4
5 **Amendment to the Drawings**

10 **REMARKS**

MARKED-UP VERSION OF THE AMENDMENTS

FIG. 11

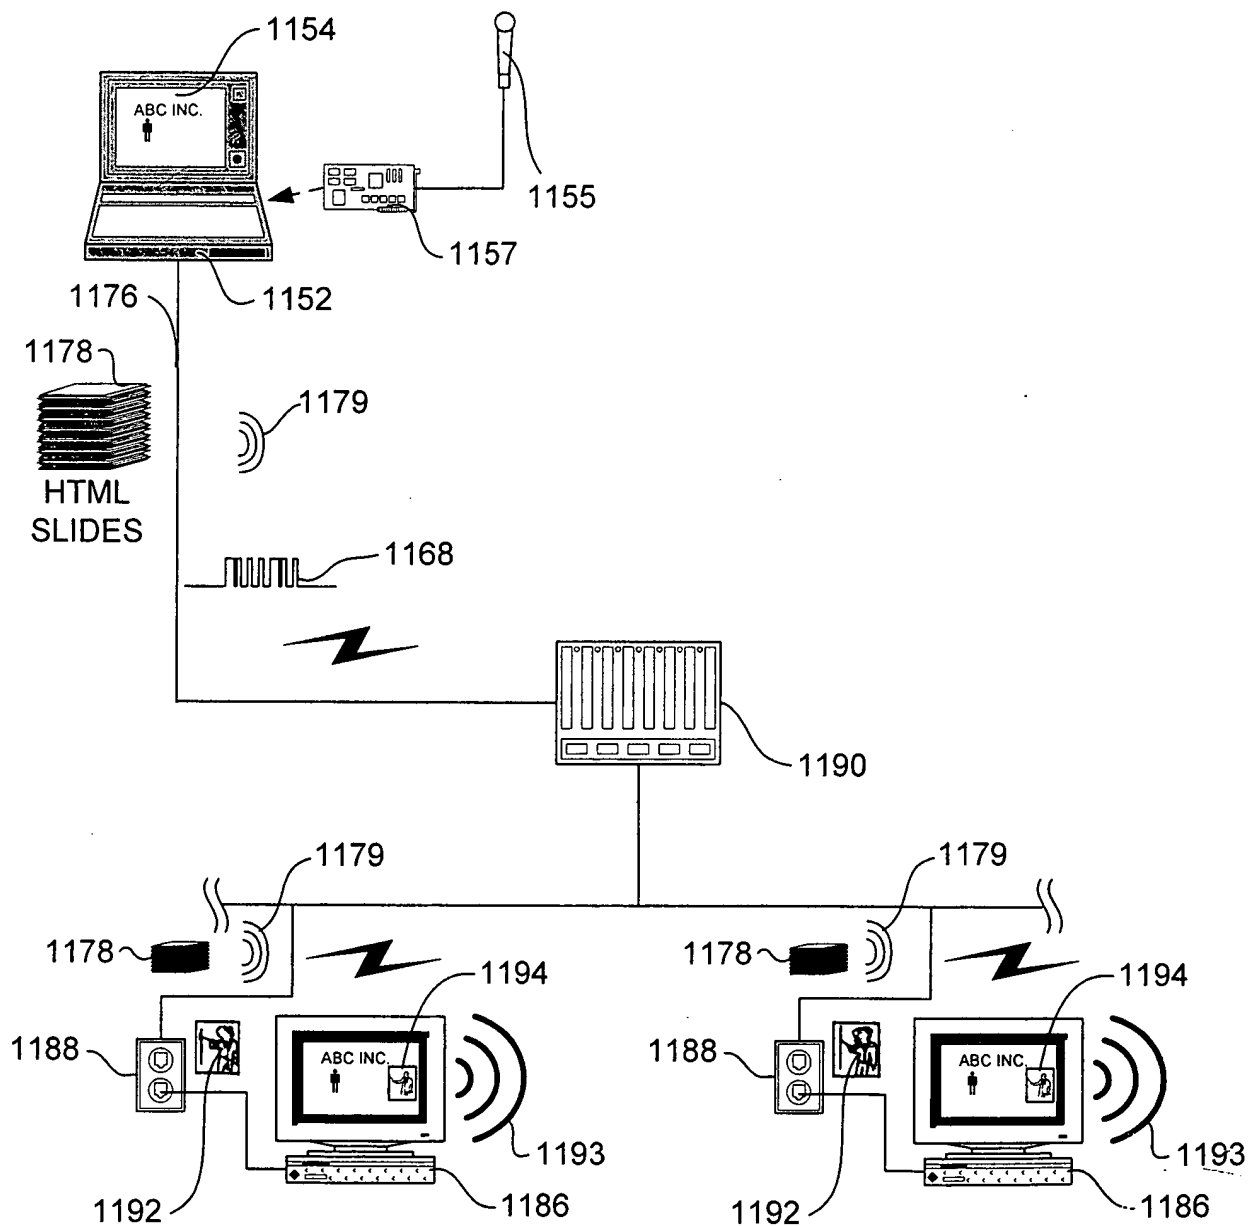
24 The drawings are objected to because it is unclear what reference number 1192 in Figure 11 is
25 pointing to. Applicants propose to add a symbol of video content to which the reference number will
26 point. The symbol of video content corresponds to that used in Figures 9 and 12 with the same
27 reference number 1192. Applicants request that the Examiner approve the proposed addition. In the
28 event the Examiner approves the proposed addition, a clean corrected drawing sheet of Figure 11 is
29 also submitted with this amendment.

FIG. 12

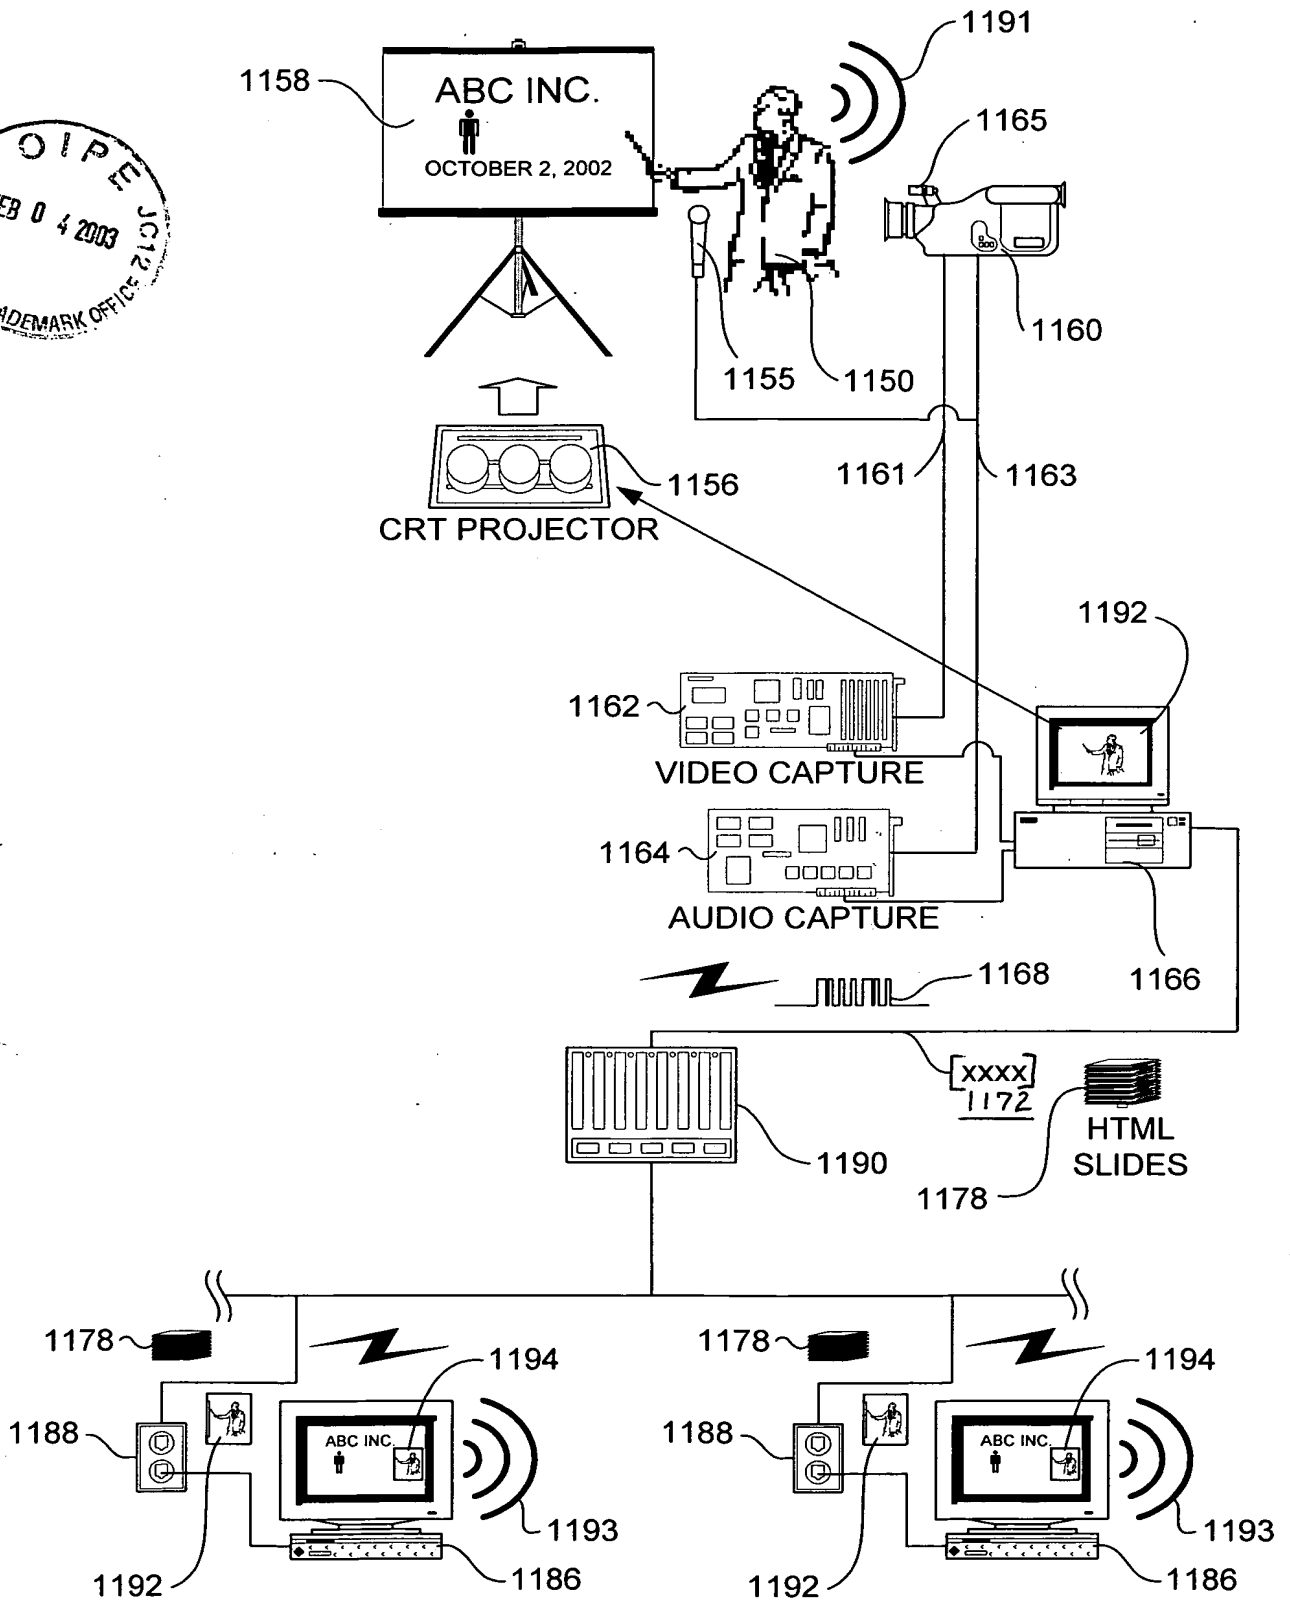
30 The drawings are also objected to because Figure 12 includes a reference "xxxx." Applicants
31 propose to replace "xxxx" with the reference number 1172, corresponding to a network
32 communication channel, similar to that shown in Figure 9. Applicants request that the Examiner
33 approve the proposed replacement. In the event the Examiner approves the proposed replacement, a
34 clean corrected drawing sheet of Figure 12 is also submitted with this amendment.
